**RE: APPROVAL OF CLASS I MODIFICATION OF SAFETY-KLEEN HAZARDOUS  
WASTE PERMIT  
SAFETY-KLEEN – ALBUQUERQUE NMD000804294  
TASK # HRMB-SKAL-99-001**

ATTACHMENT A

PROPOSED PERMIT MODIFICATION

ATTACHMENT C

BARREL WASHER/ REUSE SOLVENT SUPPLY TANK PIPING ISOMETRIC

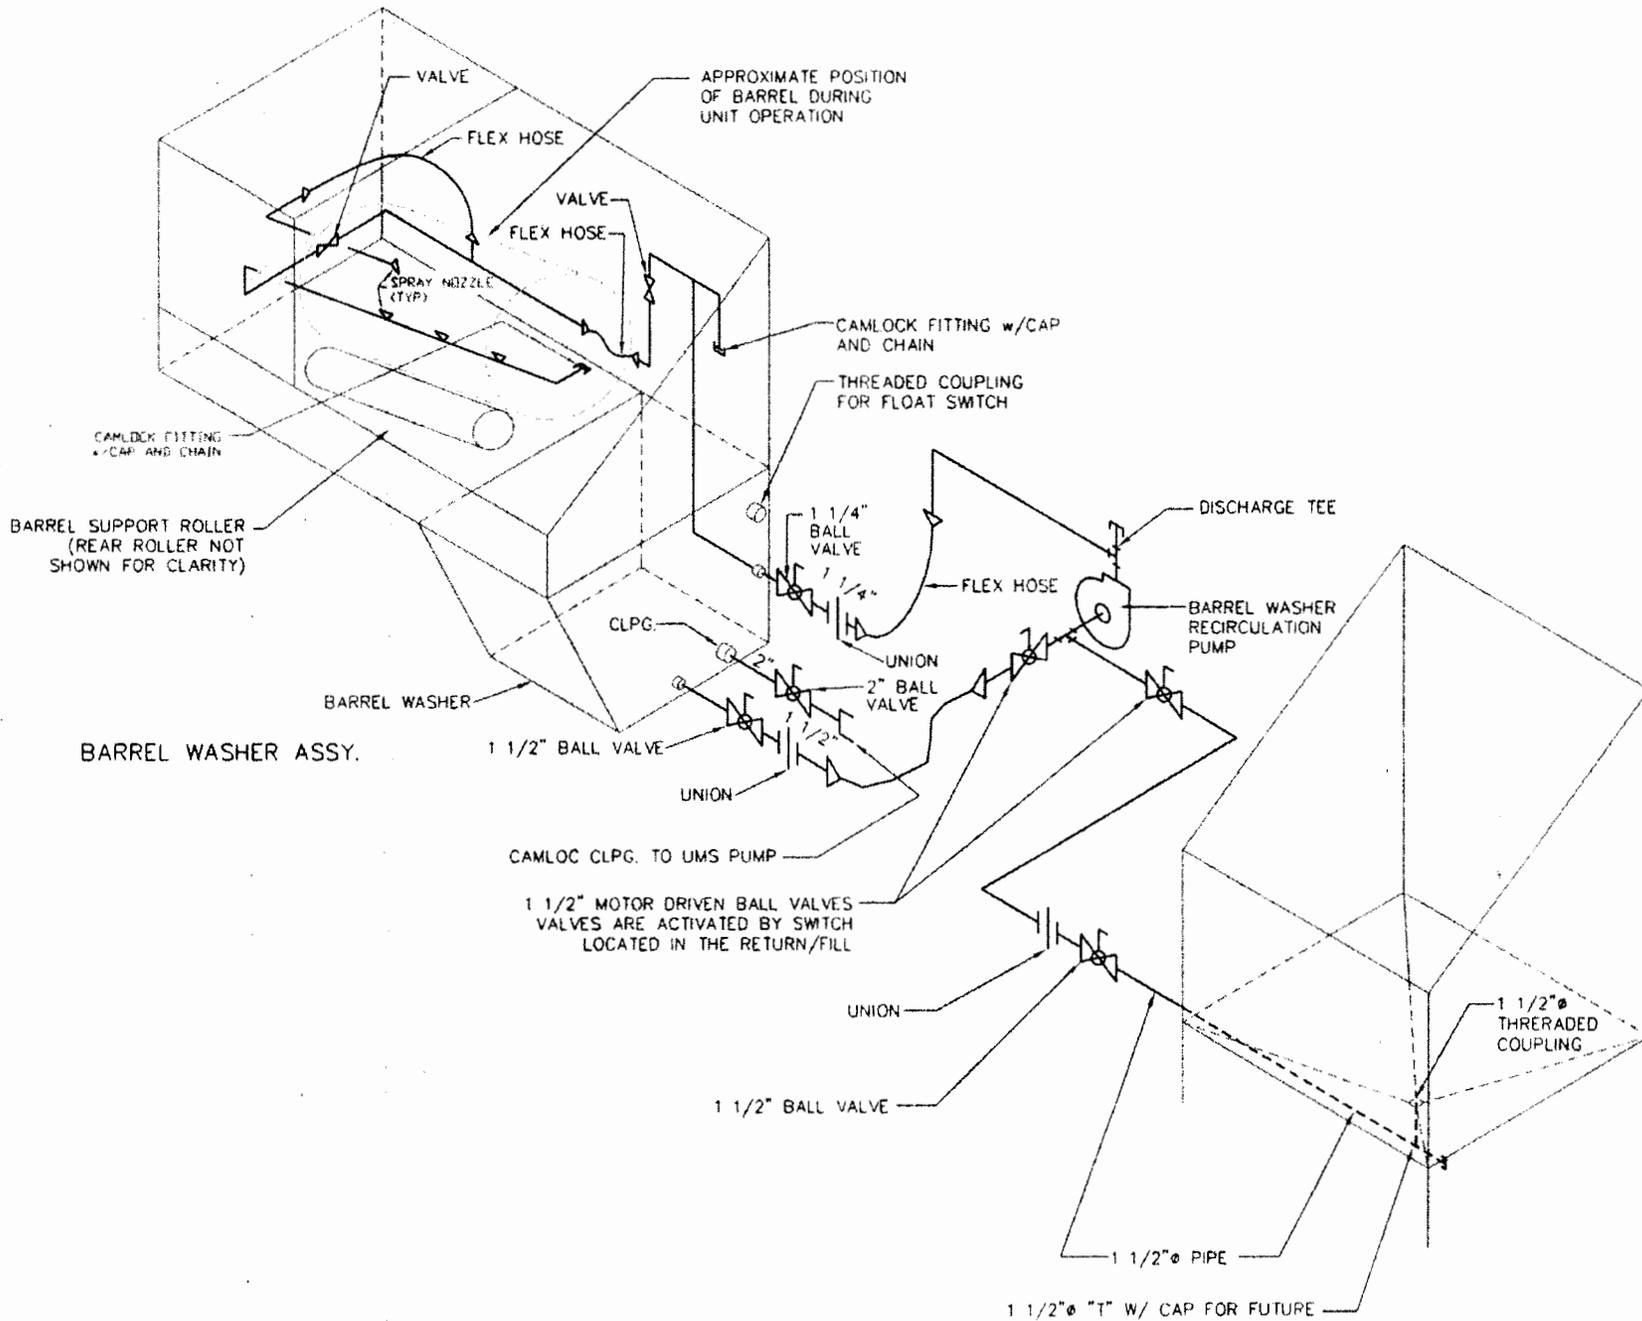
Ancillary equipment to the waste solvent tank includes a return and fill station containing two enclosed metal cabinets which serve as sumps into which the contents of a drum of used solvent can be emptied. A maximum volume of 40 gallons is retained in the sump of each metal cabinet. A float switch controls a pump that moves excess solvent to the spent solvent tank. The metal cabinet

located at the south side of the return and fill station has a jet, which cleans the sediment from the drum. The south metal cabinet is connected to an additional 200 gallon metal tank containing used parts washing solvent still retaining the capacity for less rigorous cleaning applications. This tank serves as the primary source of solvent for drum washing at the south metal cabinet. When the 200 gallon tank is empty, solvent residing in the bottom of the cabinet sump is recirculated through the drum washer for any remaining drum cleaning requirements. The metal cabinet located at the north side of the return and fill station also has a jet, which cleans the sediment from a drum. The north cabinet-drum washer recirculates solvent residing in the bottom of the cabinet when cleaning a drum. All spent solvents and sediments from each metal cabinet are then pumped into the spent solvent tank. The return and fill station has a roof and is equipped with concrete secondary containment and a blind sump with a capacity of 1,548 gallons. Piping from the return and fill station is tight piped and is protected by secondary containment. The pump, which provides clean solvent for filling drums is located within the secondary containment for the return and fill station and all its associated piping is located within this secondary containment. Fill pipes for emptying the spent solvent and filling the clean solvent tank (from tanker trucks) are secondarily contained.

Based upon the information which Safety-Kleen, Albuquerque has supplied to HRMB, NMED hereby approves the Class 1 Permit Modification for Safety-Kleen, Albuquerque. The effective date of approval is the date you receive this letter. The proposed changes are shown in Attachment A of this letter. The approved changes are in Attachments B and C of this letter. These changes have been incorporated into the Safety-Kleen, Albuquerque Hazardous Waste Permit EPA ID #: NMD000804294. You are required to incorporate the enclosed copy of Attachment B to page 1 of Module IV of the operating Permit formerly issued by NMED. You are also required to incorporate the enclosed Attachment C to the facility drawings in Attachment E of the Permit previously issued by NMED.
